APPLICATION FOR AMENDMENT  
TO TECHNICAL SPECIFICATIONS

CONSOLIDATED EDISON COMPANY  
OF NEW YORK, INC.

INDIAN POINT UNIT NO. 2  
DOCKET NO. 50-247  
FACILITY OPERATING LICENSE  
No. DPR-26

July 9, 1975

Figure 3.10-1

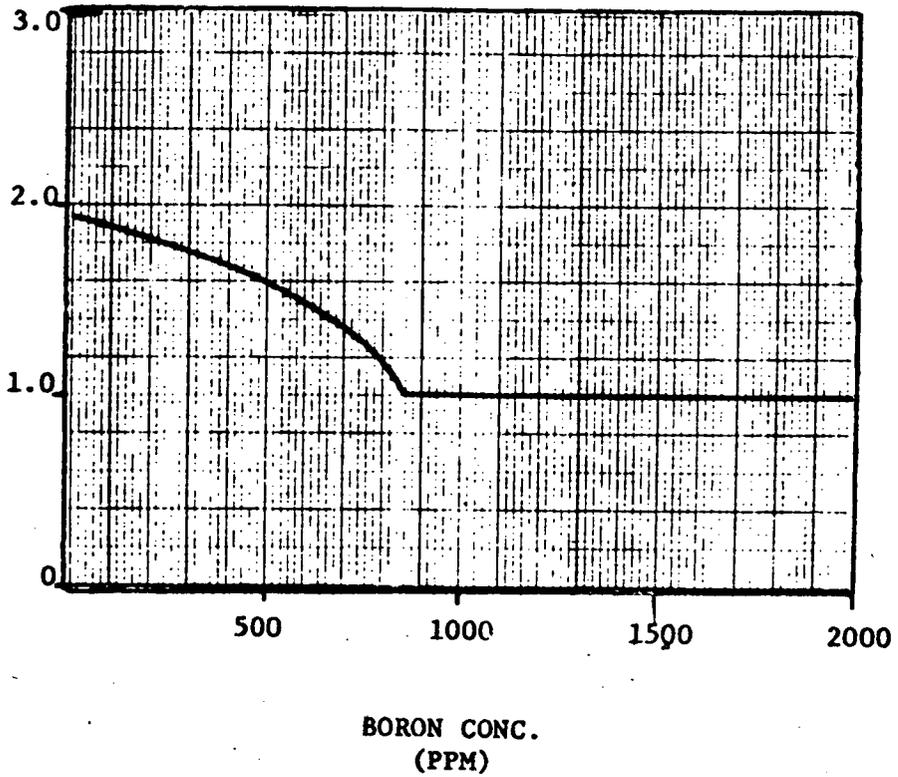
The shutdown margin shall be at least as great as shown in Figure 3.10-1.

3.10.4.1 The shutdown rods shall be fully withdrawn when the reactor is critical or approaching criticality (i.e., the reactor is no longer subcritical by an amount equal to or greater than the shutdown margin in Figure 3.10-1).

3.10.4.4 Insertion limits do not apply during physics tests or during periodic exercise of individual rods. However, the shutdown margin indicated in Figure 3.10-1 must be maintained except for the low power physics test to measure control rod worth and shutdown margin. For this test the reactor may be critical with all but one full length control rod inserted and part length rods fully withdrawn.

Figure 3.10-2 Hot Channel Factor Normalized Operating Envelope

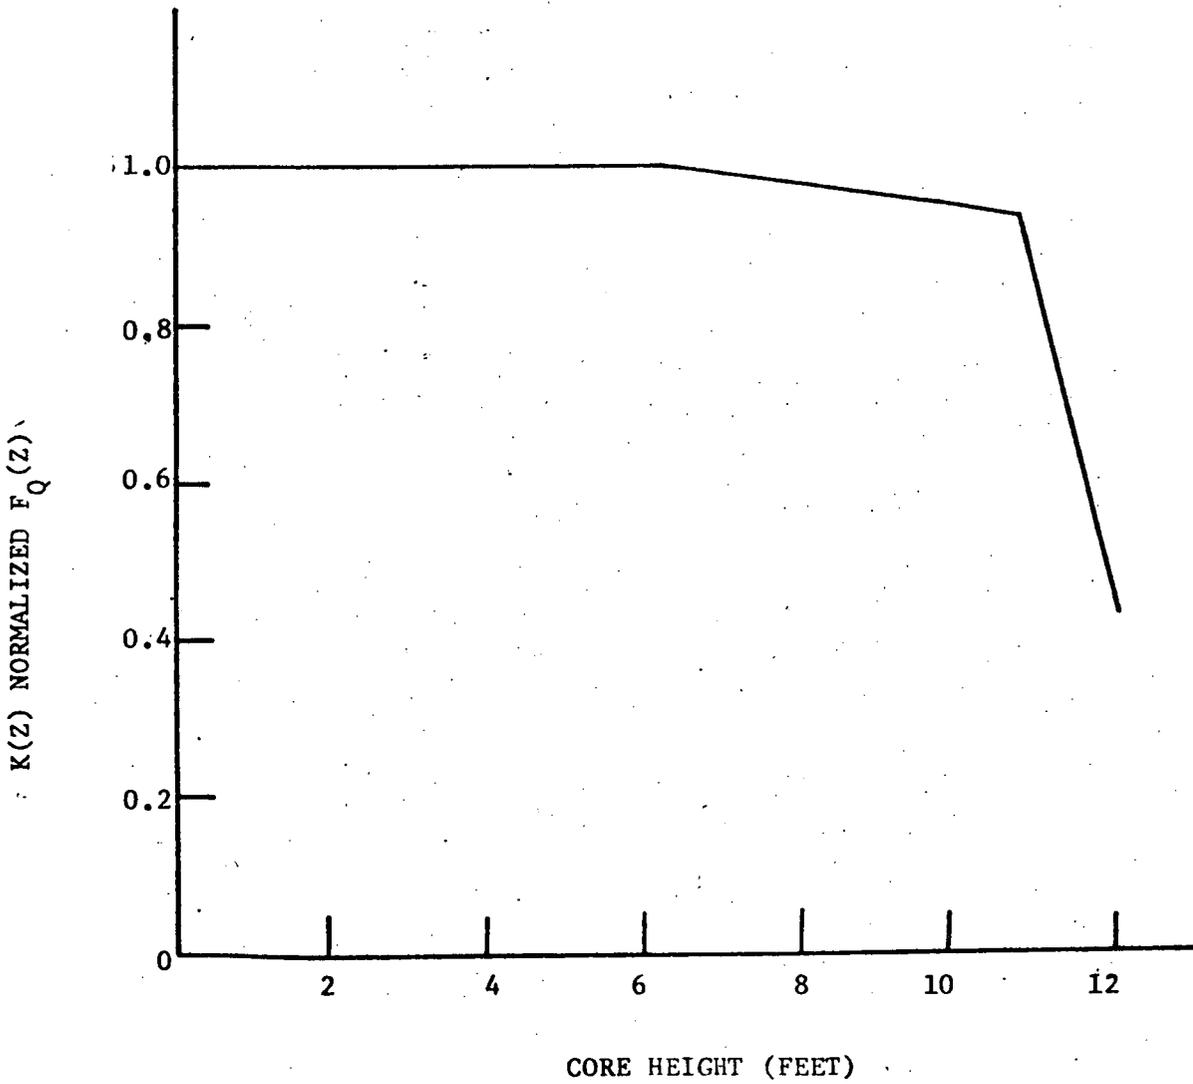
where P is the fraction of full power at which the core is operating. K(Z) is the fraction given in Figure 3.10-2 and Z is the core height location of  $F_Q$ .

An upper bound envelope of 2.32 times the normalized peaking factor axial dependence of Figure 3.10-2 has been determined from extensive analyses considering all operating maneuvers consistent with the technical specifications on power distribution control as given in Section 3.10. The results of the loss of coolant accident analyses based on 2.32 times the normalized envelope of Figure 3.10-2 indicate a peak clad temperature of 1997°F for the double-ended cold leg guillotine break with  $C_D = 0.6$ . This corresponds to a 203°F margin to the 2200°F limit. [1]

The technical specifications on power distribution control assure that  $F_Q$  upper bound envelope of 2.32 times Figure 3.10-2 is not exceeded and xenon distributions are not developed which at a later time, would cause greater local power peaking even though the flux difference is then within the limits specified by the procedure.

$$F_Q(Z) \leq (2.32/P) \times K(Z) \text{ for } P > .5$$

$$F_Q(Z) \leq (4.64) \times K(Z) \text{ for } P \leq .5$$

Figure 3.10-3 Insertion Limits 100 Step Overlap  
Four Loop Operation

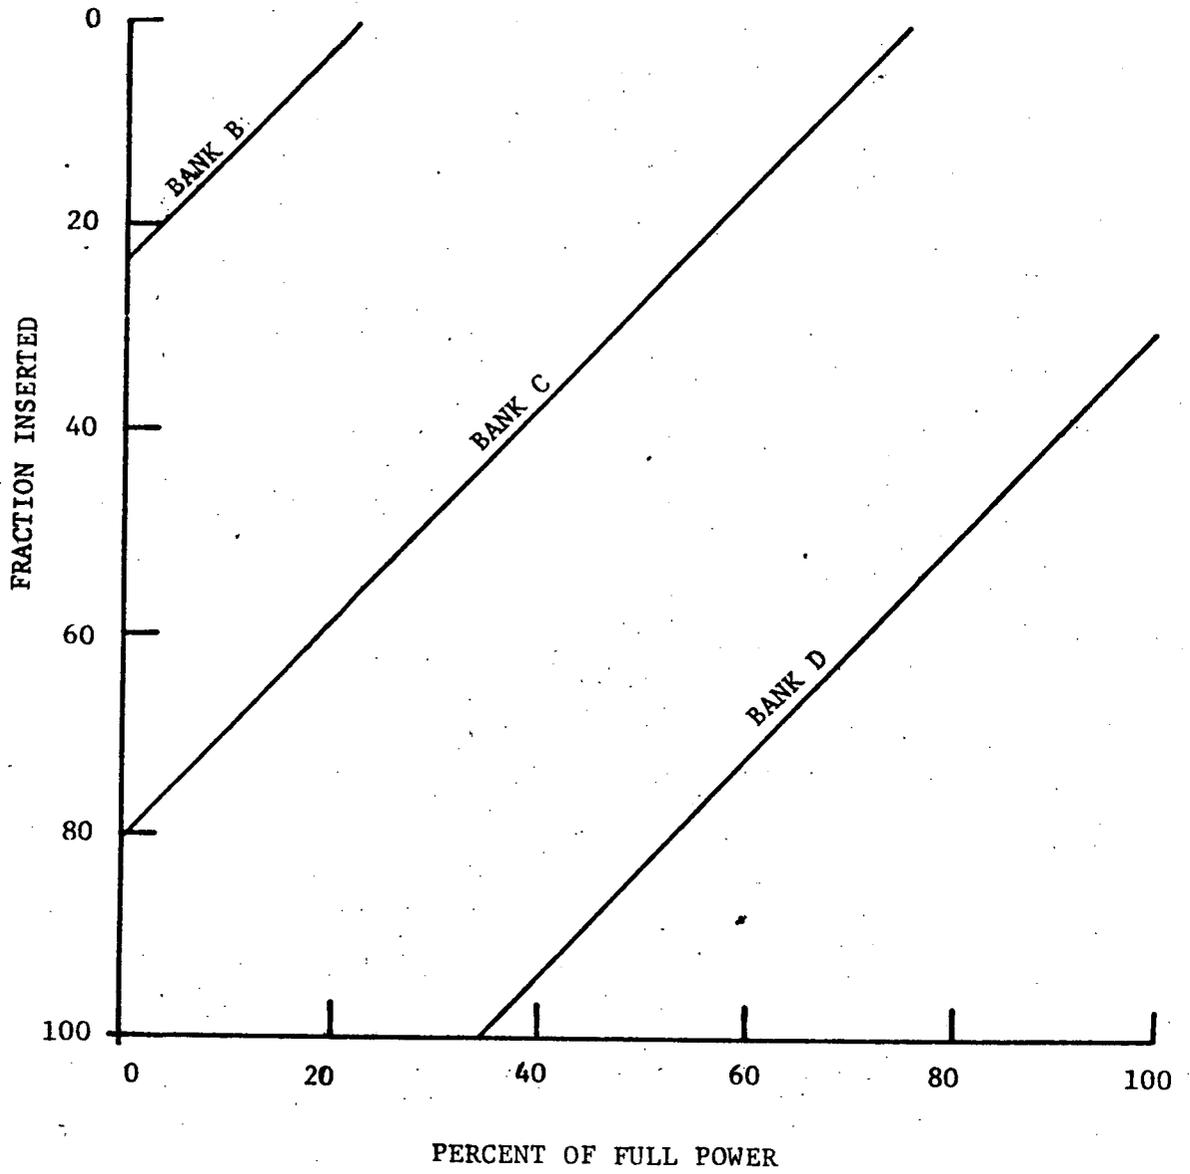
3.10.4.2 When the reactor is critical, the control banks shall be limited in physical insertion to the insertion limits shown in Figure 3.10-3 or Figure 3.10-4.

Figure 3.10-6

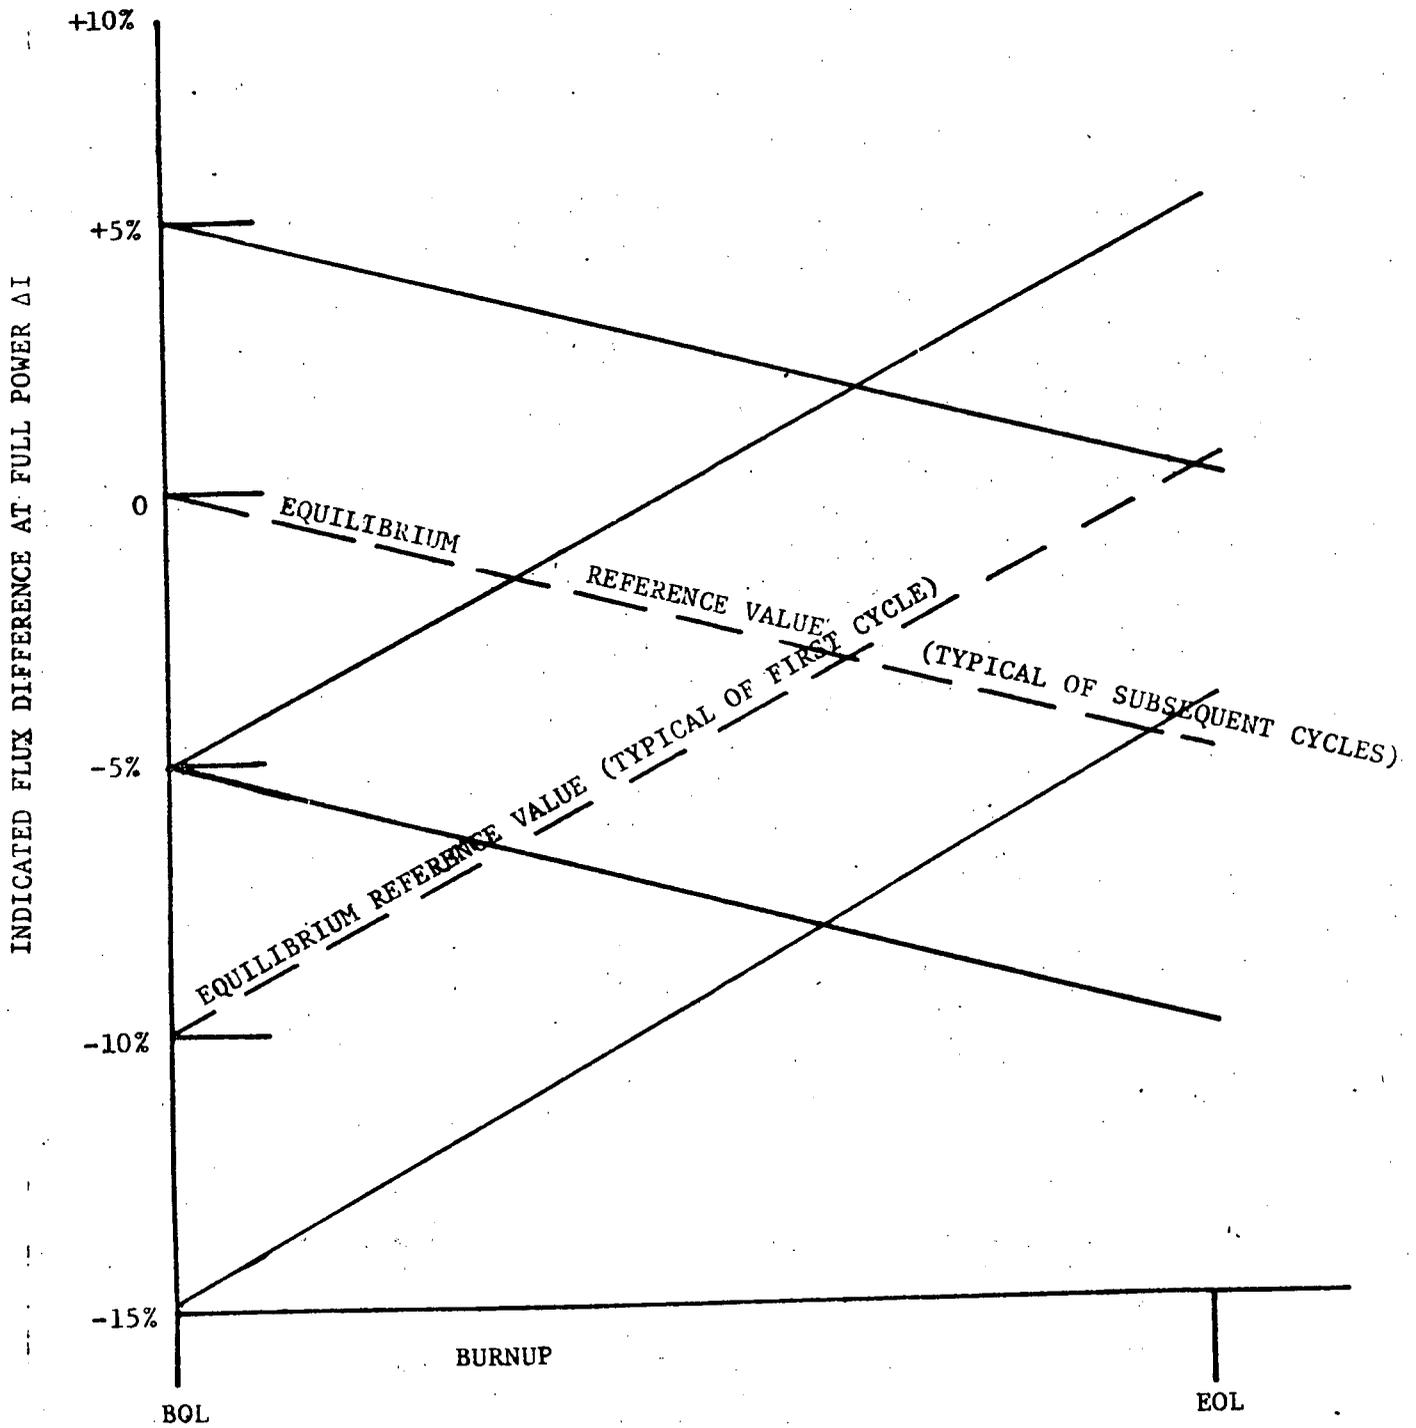
The target (or reference) value of flux difference is determined as follows. At any time that equilibrium xenon conditions have been established, the indicated flux difference is noted with part length rods withdrawn from the core and with the full length rod control rod bank more than 190 steps withdrawn (i.e. normal full power operating position appropriate for the time in life, usually withdrawn farther as burnup proceeds). This value, divided by the fraction of full power at which the core was operating is the full power value of the target flux difference. Values for all other core power levels are obtained by multiplying the full power value by the fractional power. Since the indicated equilibrium value was noted, no allowances for excore detector error are necessary and indicated deviation of  $\pm 5$  percent  $\Delta I$  are permitted from the indicated reference value. During periods where extensive load following is required, it may be impractical to establish the required core conditions for measuring the target flux difference every month. For this reason, the specification provides two methods for updating the target flux difference. Figure 3.10-5 shows a typical construction of the target flux difference band at BOL and Figure 3.10-6 shows the typical variation of the full power value with burnup.
